**Los Alamos National Laboratory's Response to Written Public Comments Submitted Regarding
Request for Alternative Compliance for S-SMA-2 and S-SMA-0.25**

Re: Alternative Compliance at S-SMA-2 and S-SMA-.25

Please accept the following comments on behalf of Communities for Clean Water (CCW) on the Alternative Compliance Requests for S-SMA-2 and S-SMA-.25.

LANL SWMU Drainage Area & SW BMPs

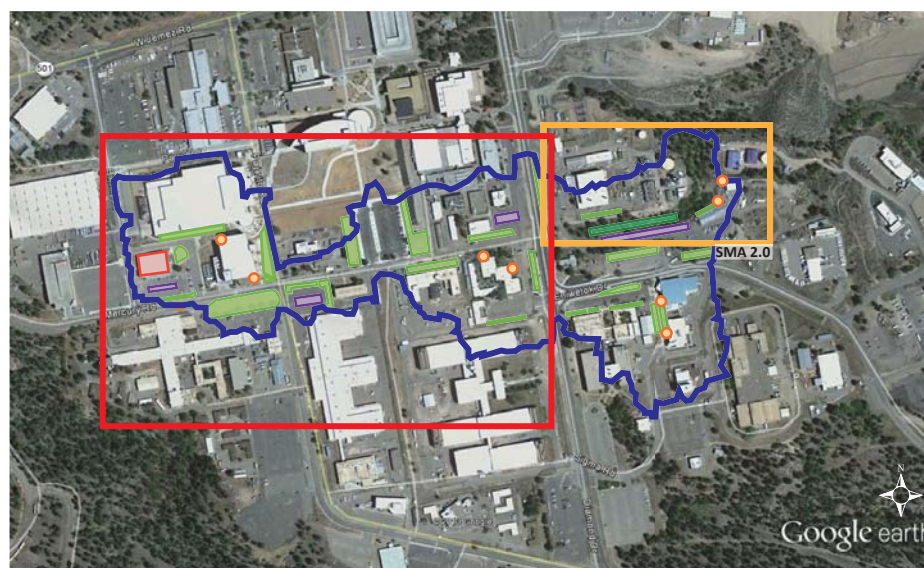
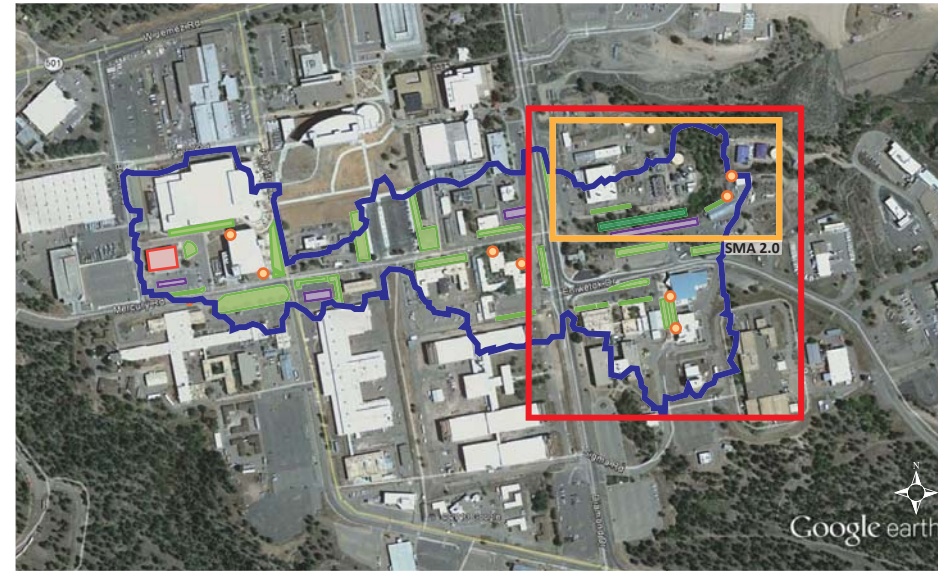
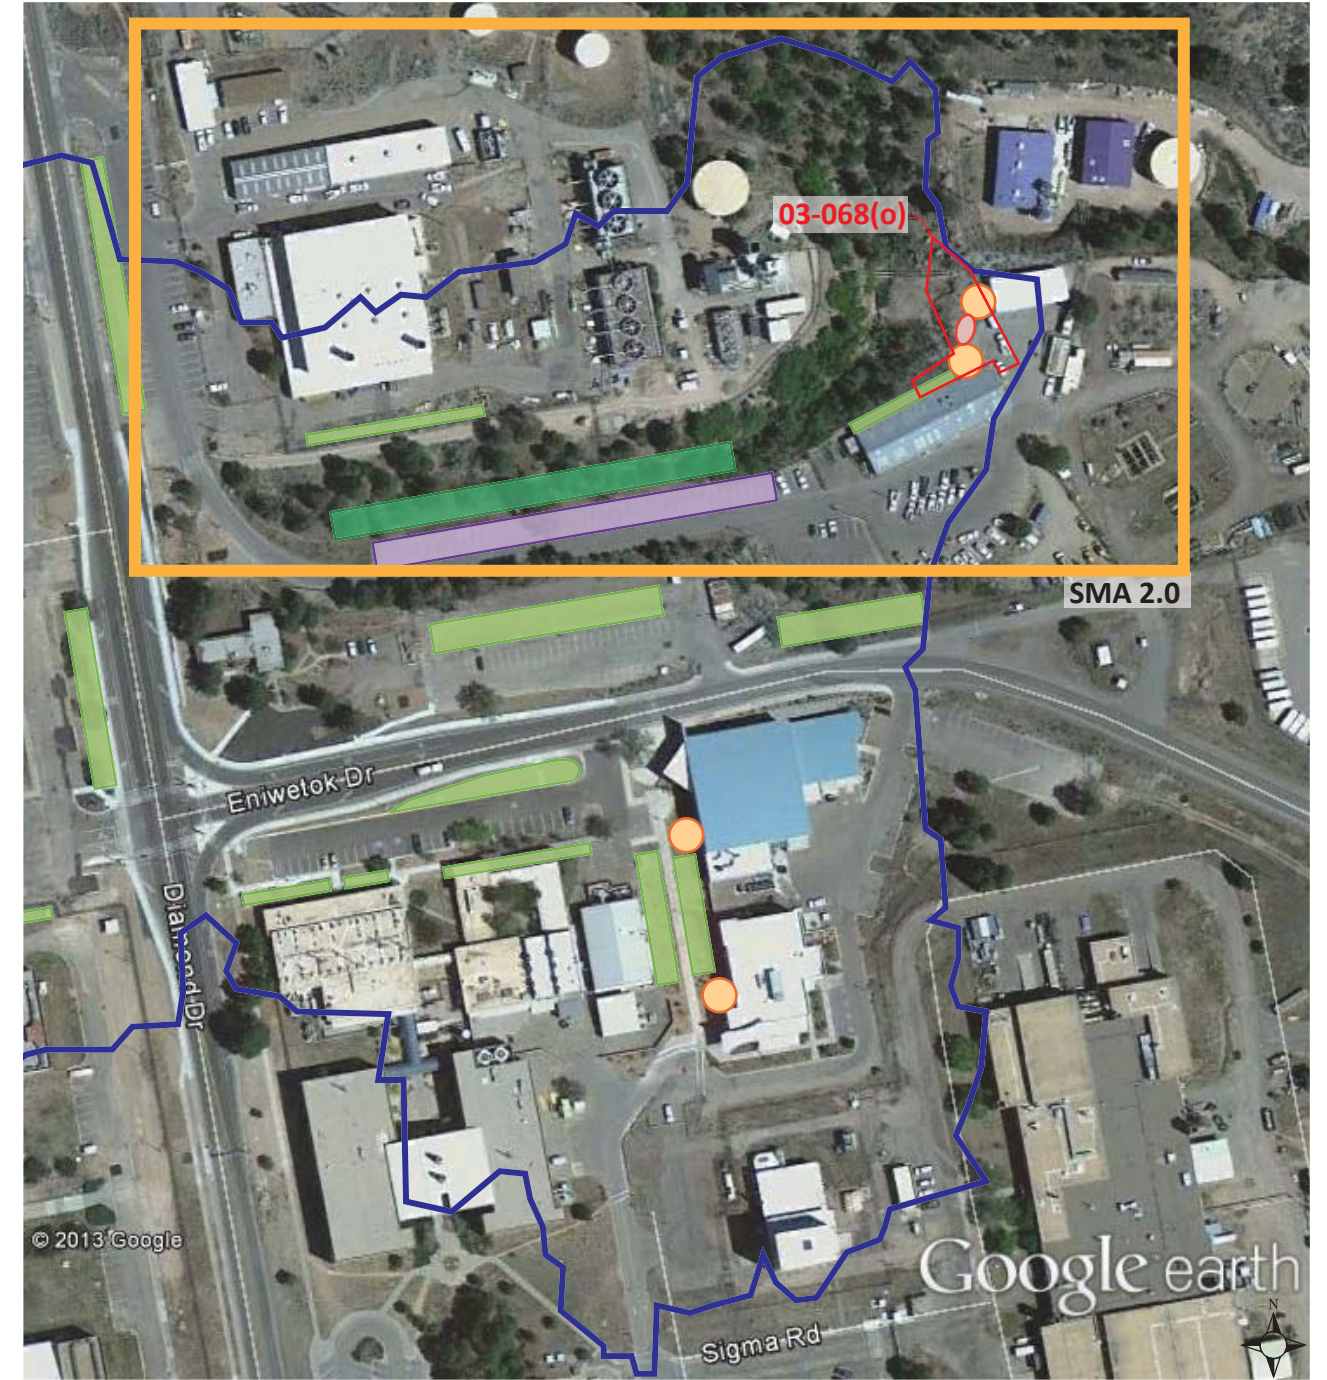
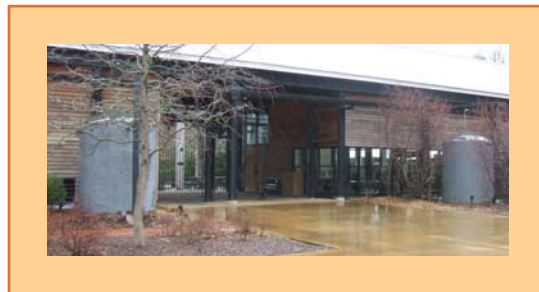
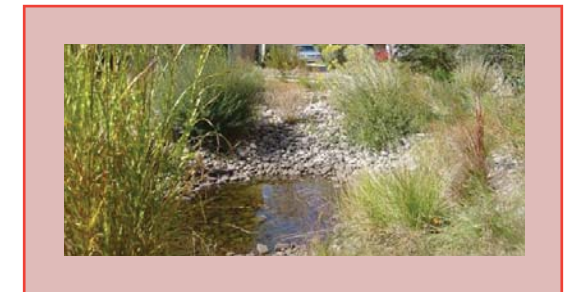
Several alternative treatment strategies have been identified (by Biohabitats, Inc. for CCW and communicated to LANL at technical meetings and written reports) throughout S-SMA-0.25 (see attachment 1), but many are being rejected (Table 7) for a range of reasons. For every objection, we could enter into more detailed discussion on feasible alternatives or modifications. There are numerous locations to implement retrofits and develop an on-site knowledge base of what works well and what doesn't. To our knowledge, there are no advanced stormwater treatment BMPs on the LANL campus from which to derive conclusions. We view this as a great opportunity to implement, monitor practice performance, and adapt designs so these applications can successfully be applied to clean up laboratory runoff. While potential BMP locations were not previously provided for S-SMA-2, this SMA contains a similar range of

opportunities. We have provided some potential BMPs and BMP locations for S-SMA-2 in attachments 2 and 3.

- Corrective Actions (Section 8.0 in both requests)
 - Upland BMP implementation is not fully explored within S-SMA-0.25 or S-SMA-2. Objections due to “a large amount of maintenance” or infeasible due to utility conflicts are not substantiated. Many opportunities exist in both SMAs. No opportunities were explored or pursued in S-SMA-2.
